NEW SKETCH

Document Number: Gas Cylinder 1100 LW

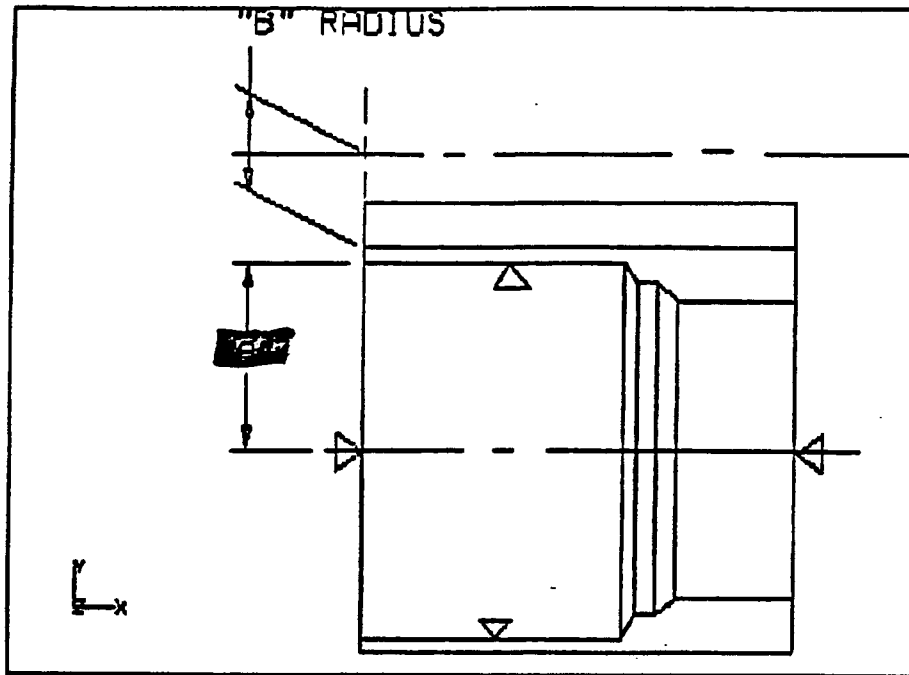
- DIMENSION "A" INCORRECTLY COPIED FROM PRIOR SKETCH.
 - HIDDEN LINES MADE SOLID; IMPLIES SECTION VIEW BUT OMITTS CROSS HATCHING. THIS MAKE VIEWER UNSURE OF WHAT IS BEING PRESENTED.
 - SOLID/OUTLINE TRIANGLES HAVE DIFFERENT MEANING IN PRIOR SKETCH. THIS INFO LOST IN NEW SKETCH.
- ⇒ IS THERE A QUALITY SYSTEM ELEMENT IN PLACE TO REVIEW THESE?
